ANN ARBOR HISTORIC DISTRICT COMMISSION

Staff Report

ADDRESS: 122 South Seventh St, Application Number HDC19-011

APPLICATION: The applicant seeks HDC approval to replace a crawlspace foundation beneath a pre-1947 addition with a basement, and install two egress windows with wood timber wells.

FOUNDATION WALL SECTION

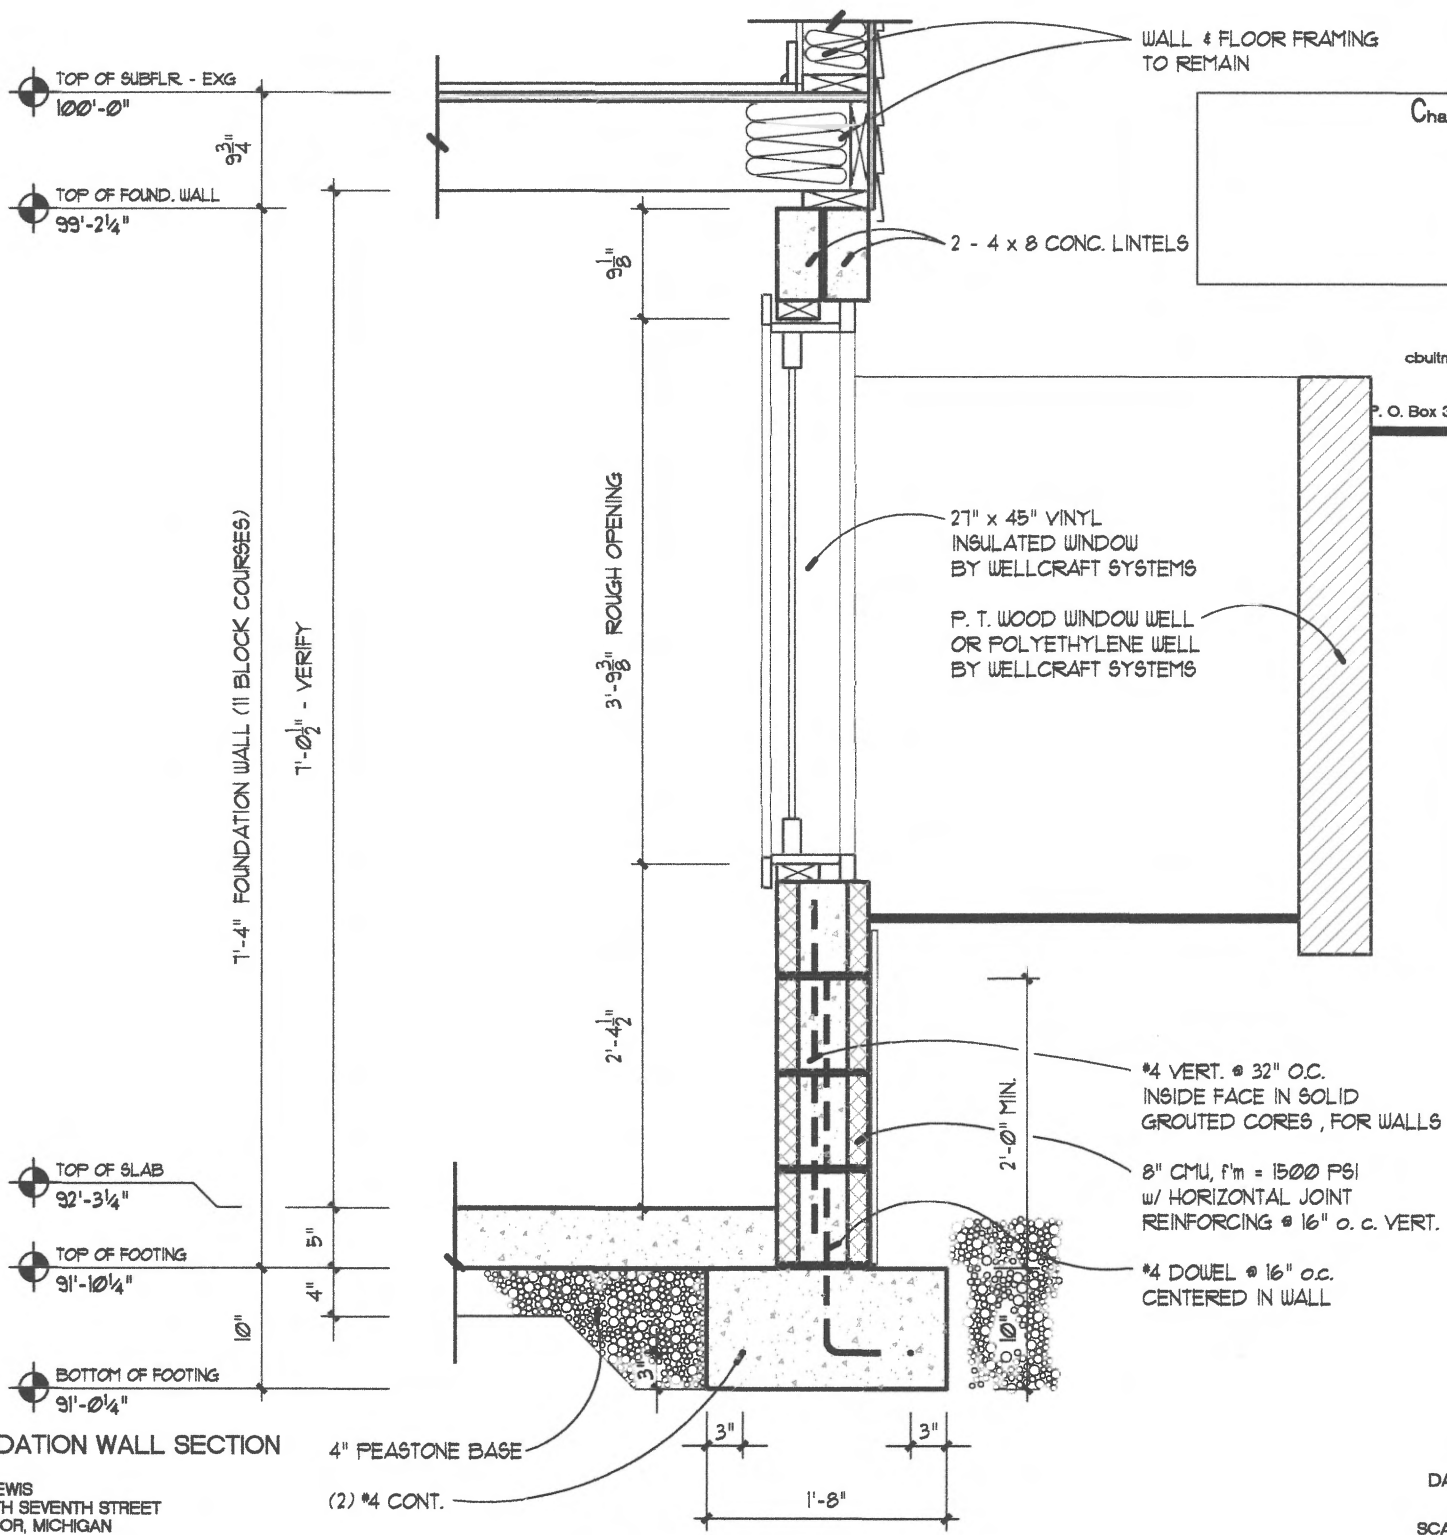
1) The window wells at grade are 4' (N/S) by 3' (E/W), and the well is 45" deep?

3) The well material will be wood, not polyethylene?

Correct

Correct, same as east wall in new basement area
